# ENVIRONMENTAL RE-EVALUATION FORM

State File #		Fed Project #	P027662	Project ID	P027662	Route	I-20/I-26/I-126	County	Lexington and Richland
--------------	--	---------------	---------	------------	---------	-------	-----------------	--------	------------------------

Project Name: I-20, I-26, I-126 Carolina Crossroads Corridor Improvements

# NEPA Re-evaluation

Figure 1. Updated Impacts in northern half of NSA X

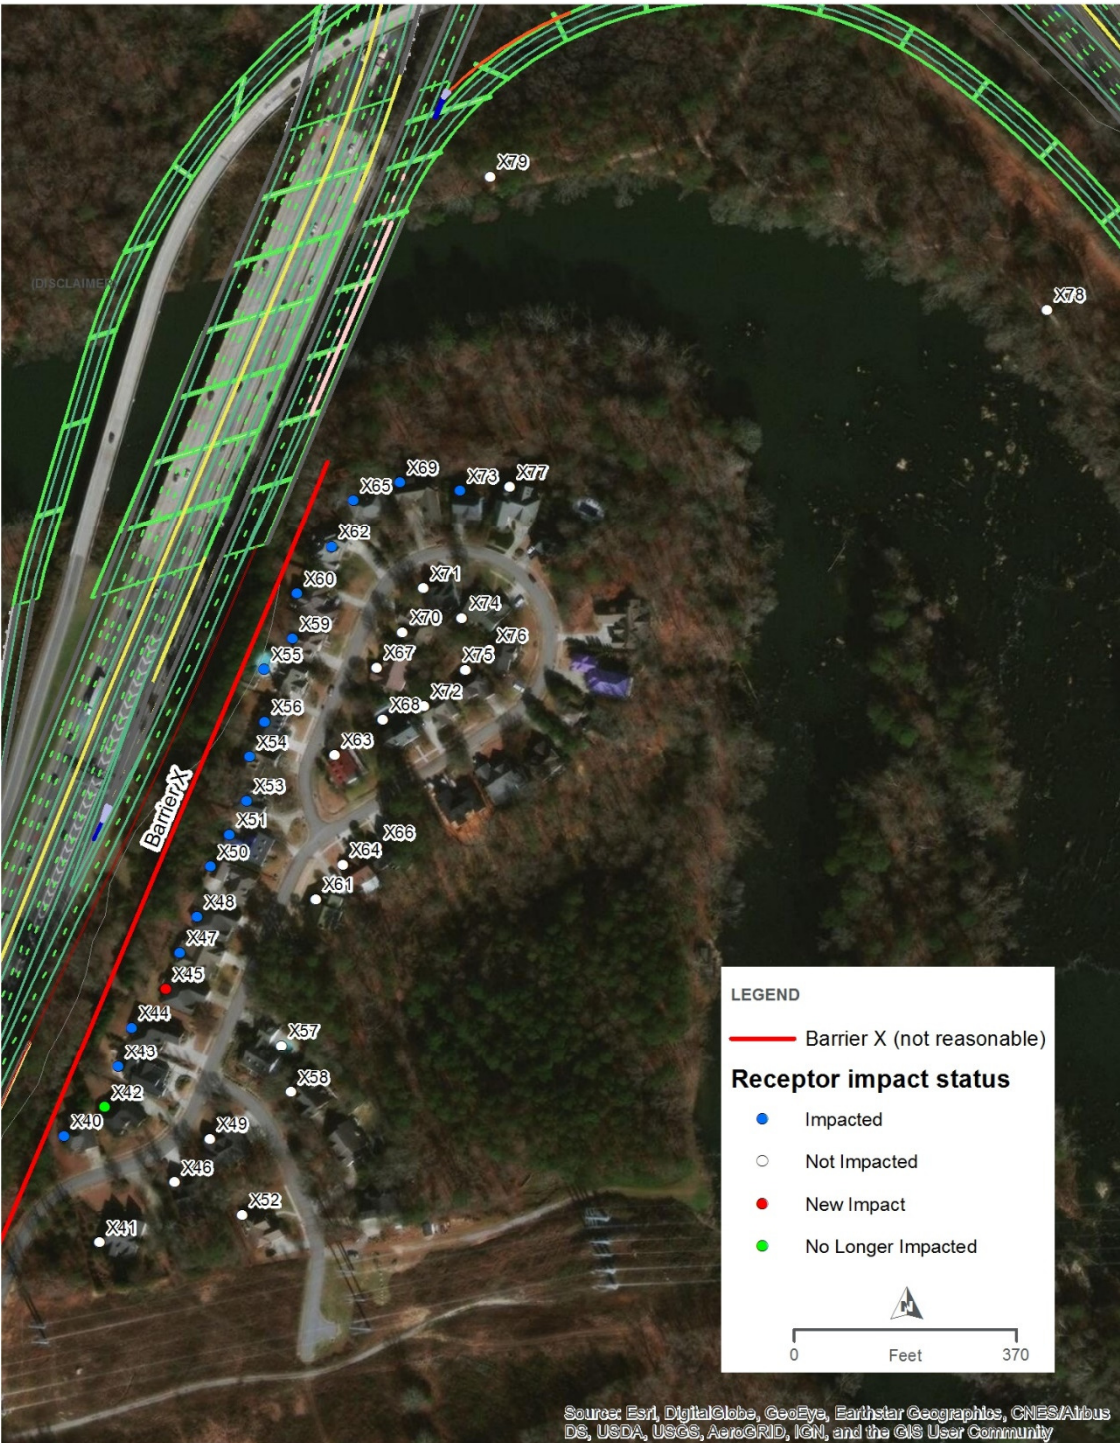
The largest increase in build noise levels was 1.8 dB, and the largest decrease was 1.7 dB. Two receptors changed impact status: X42 changed from impacted to non-impacted, and X45 changed from non-impacted to impacted. Therefore, the overall number of noise impacts in the project remains the same. The updated impact information is shown in Figure 1 below.

Due to design changes in the vicinity of NSA X, the noise analysis in that area was updated, including the build model and the barrier analysis. No change greater than 2 dB was observed. One receptor changed impact status from non-impacted to impacted, and one receptor changed impact status from impacted to non-impacted. The barrier status remains not reasonable.

Pink boxes indicated photo/figure locations in attached memo.

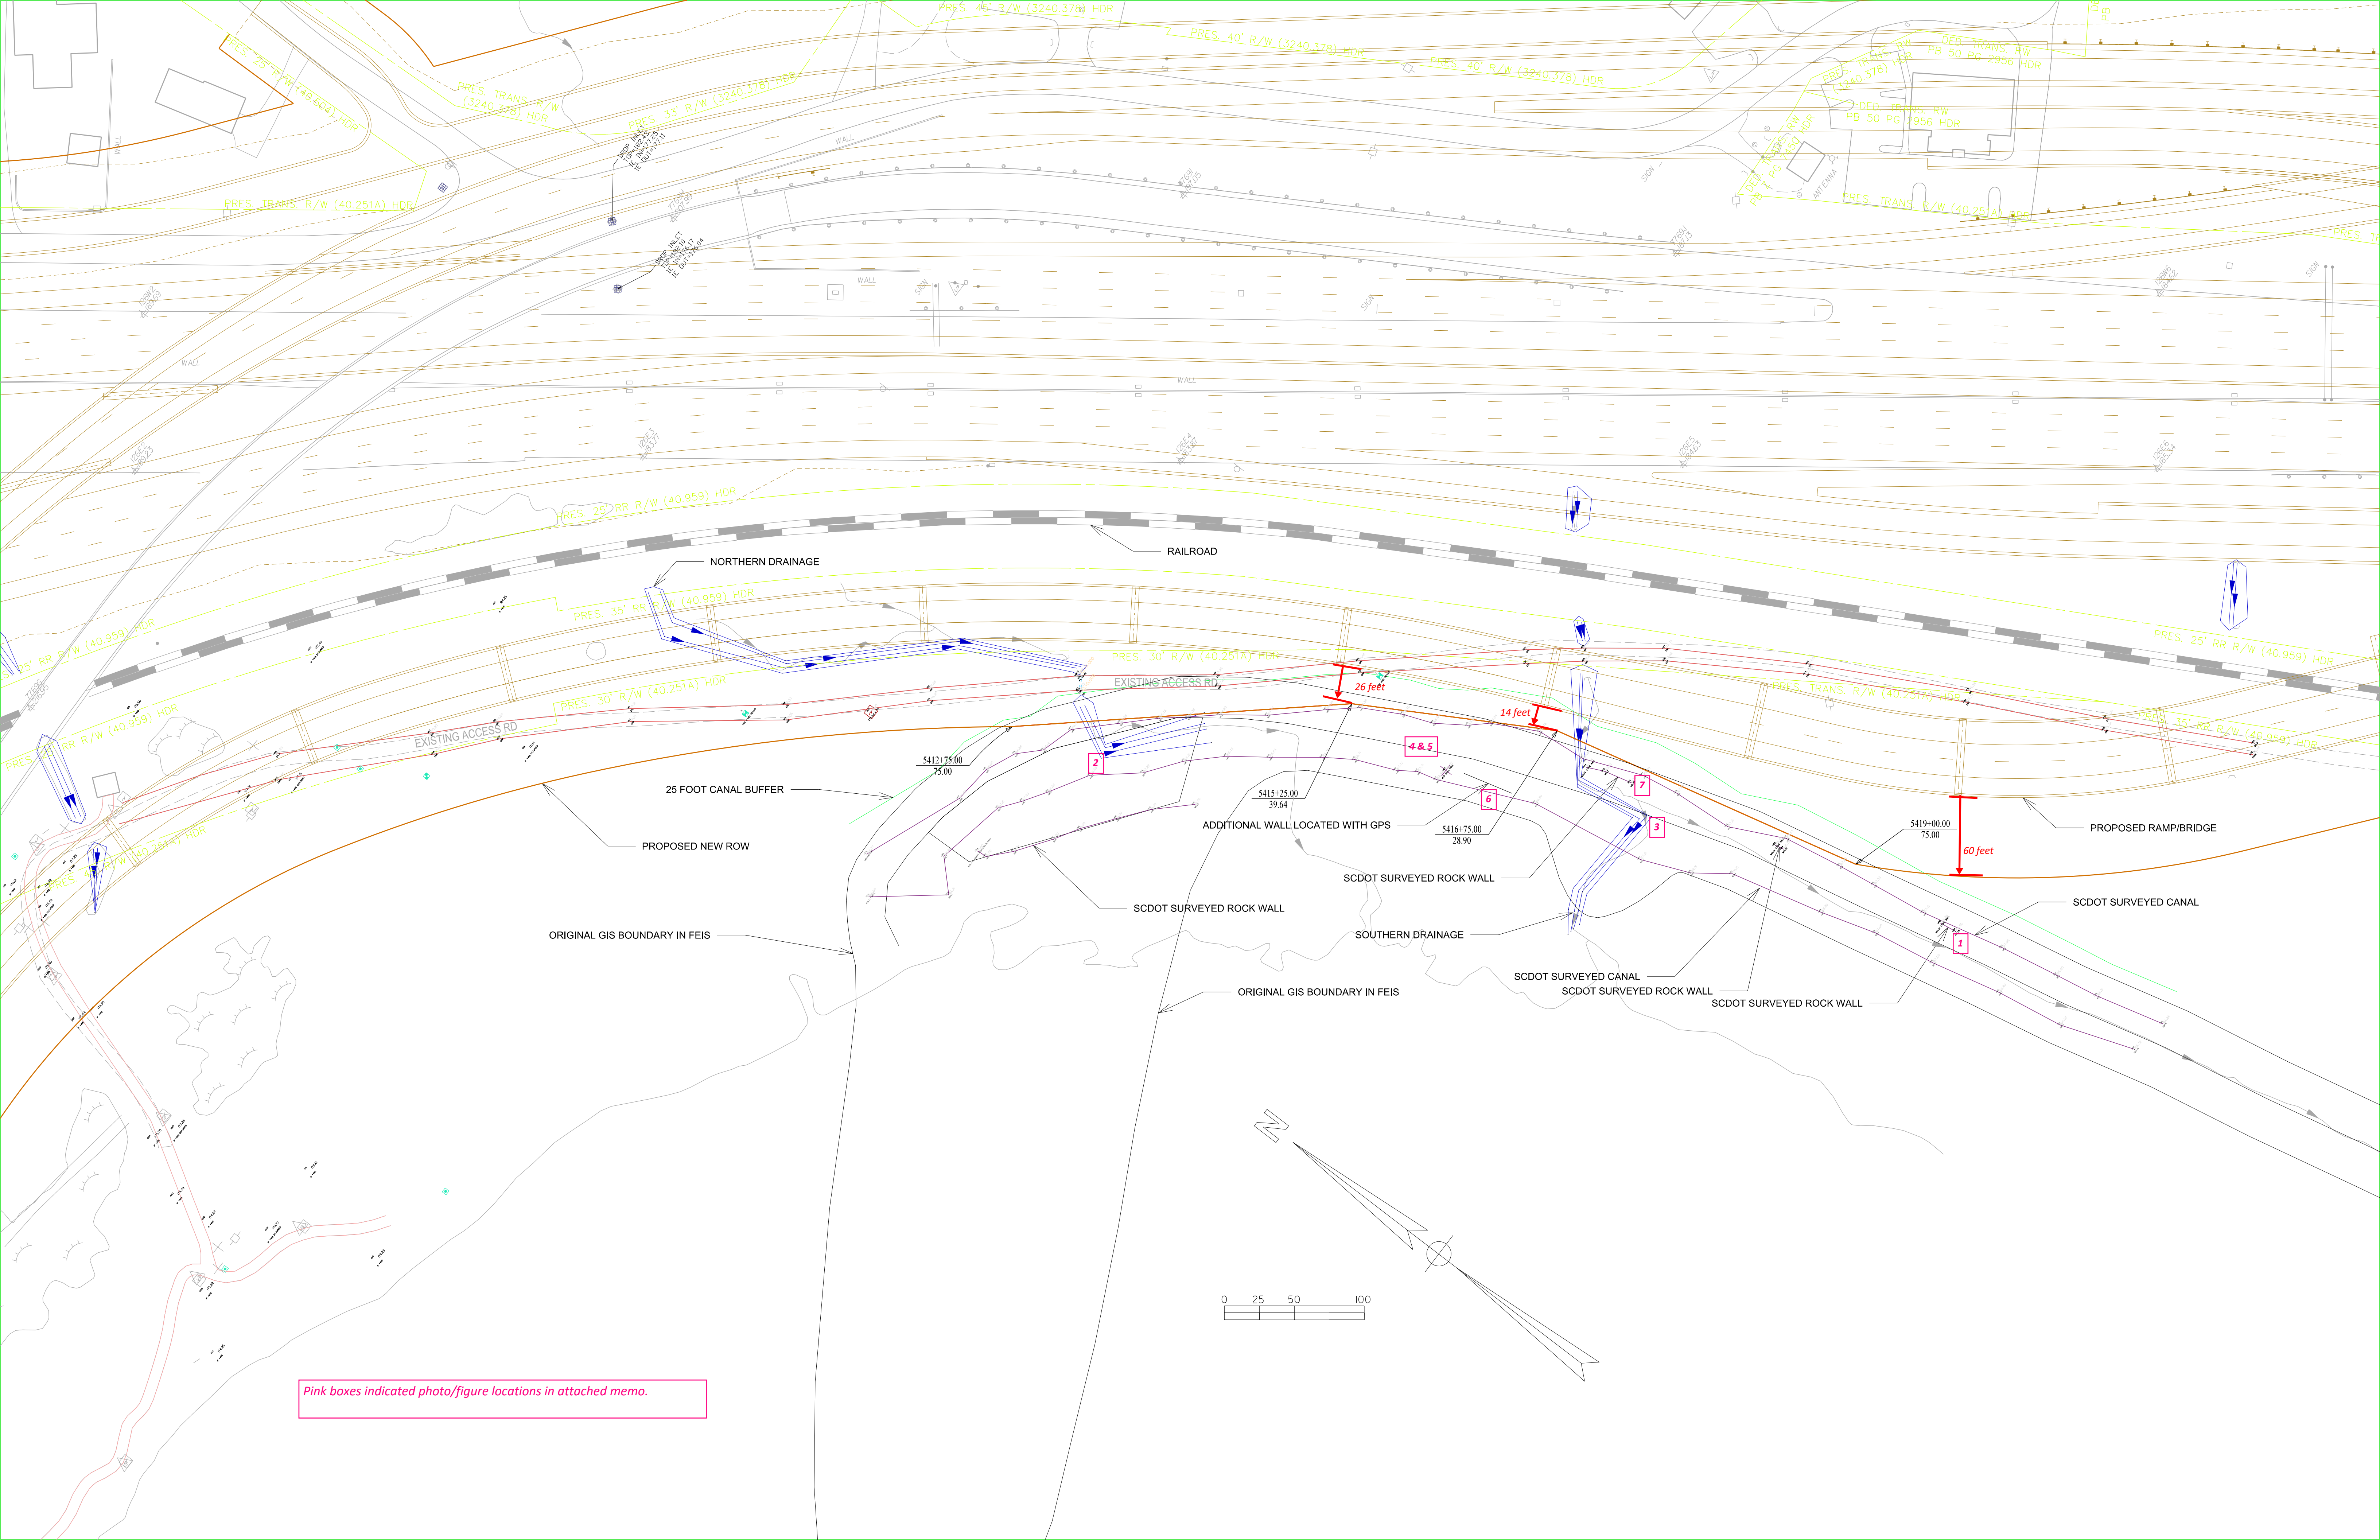
SCDOT proposes to revise the commitment of a 25-foot buffer for a distance of approximately 700 feet along the proposed ramp to allow room for temporary construction access and equipment. The following mitigation will be implemented instead:

In order to protect the boundary of the canal and the features associated with it, the following will be added to the contract as commitments:
